Serial No.: 10/677,425

For: SHARED BUFFER HAVING  
HARDWARE CONTROLLED  
BUFFER REGIONS

**RESPONSE TO OFFICE ACTION DATED MARCH 9, 2006**

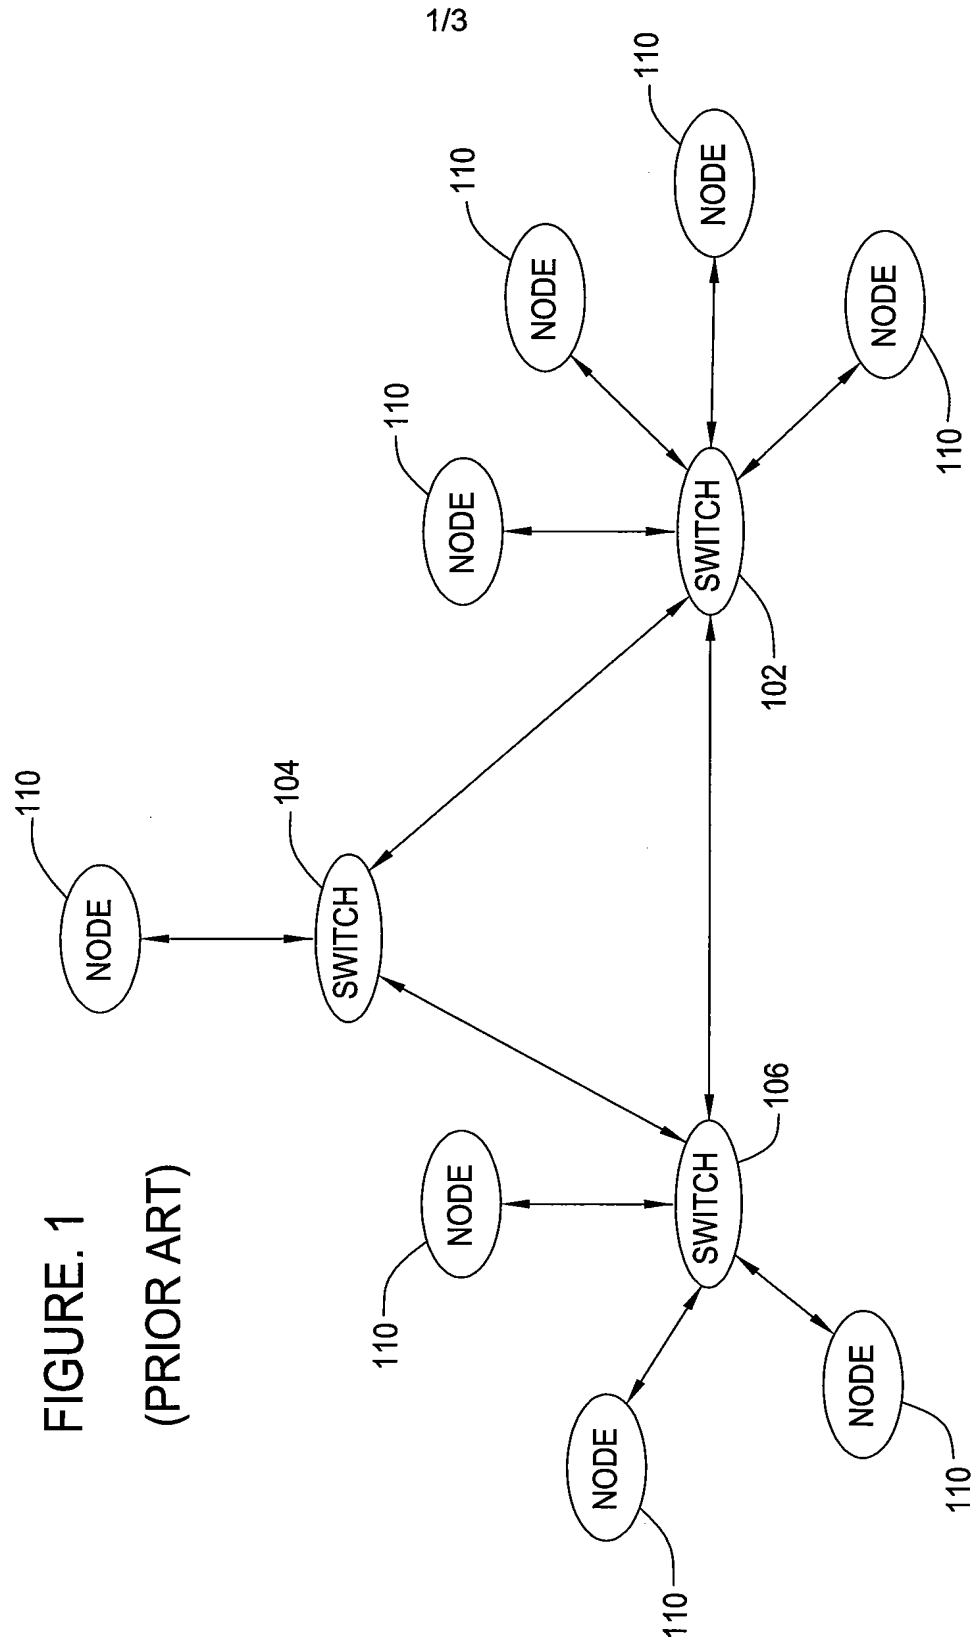
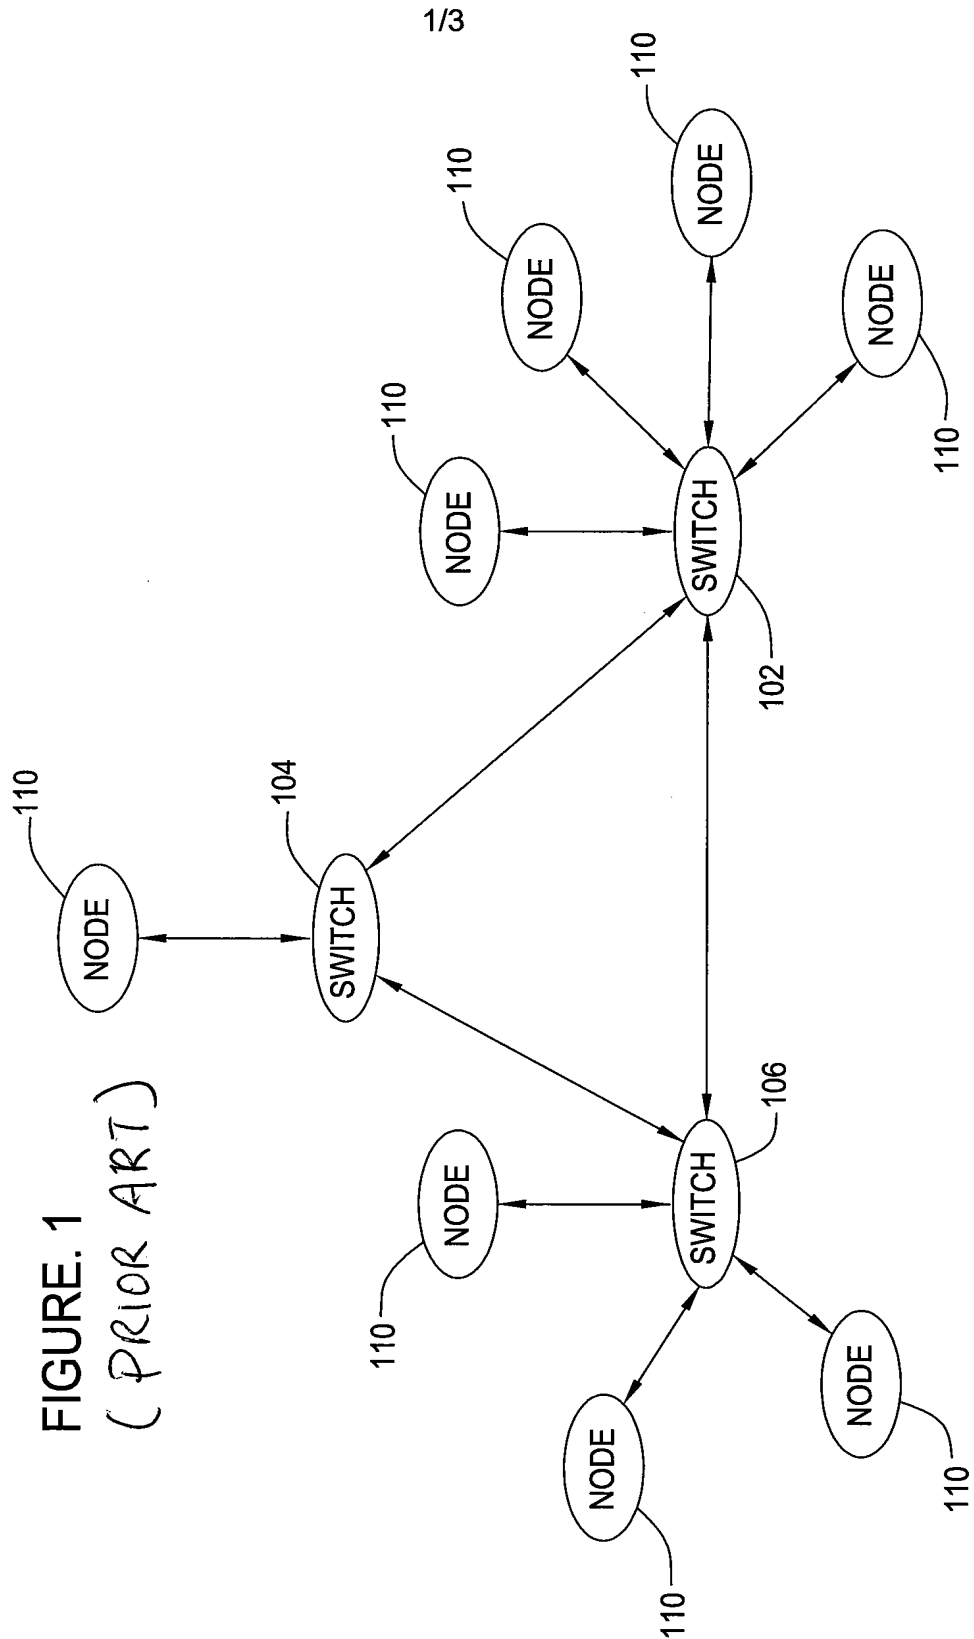
Figures 1 and 2 were objected to under MPEP § 608.02(g) as to lacking the designation of "Prior Art" because only that which is old is illustrated. Figures 1 and 2 have been corrected in compliance with 37 CFR 1.121(d) as requested by the Examiner. Further, the replacement sheets associated with these drawings have been labeled "Replacement Sheet" in the page header (as per 37 CFR 1.84(c)) so as not to obstruct any portion of the drawing figures.

The attached sheet of drawings includes changes to Figs. 1 and 2.
